Access Compliance Report Public Rights-of-Way (Curb Ramps)

Main Street: WALLINGSFORD_RD Cross Street: RUTH_ELAINE_DR Location: SW

ADA ID: RPRK220217193248 Ramp Type: Type 1 - Perpendicular Diagonal Initial Pass/Fail: Pass Overall Compliance: No Severity Score: 10

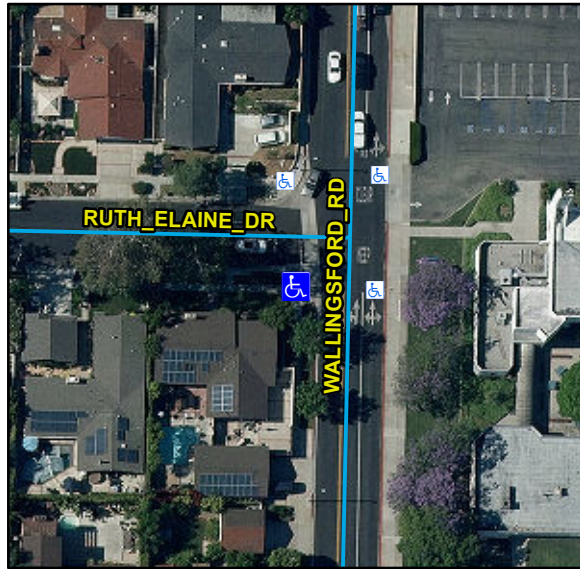
R204.3, R304.2.2-Perp, R304.3.2-Para, R305, STD 1115

Remove & Replace Curb Ramp With Two New Directional Ramps or Equivalent.
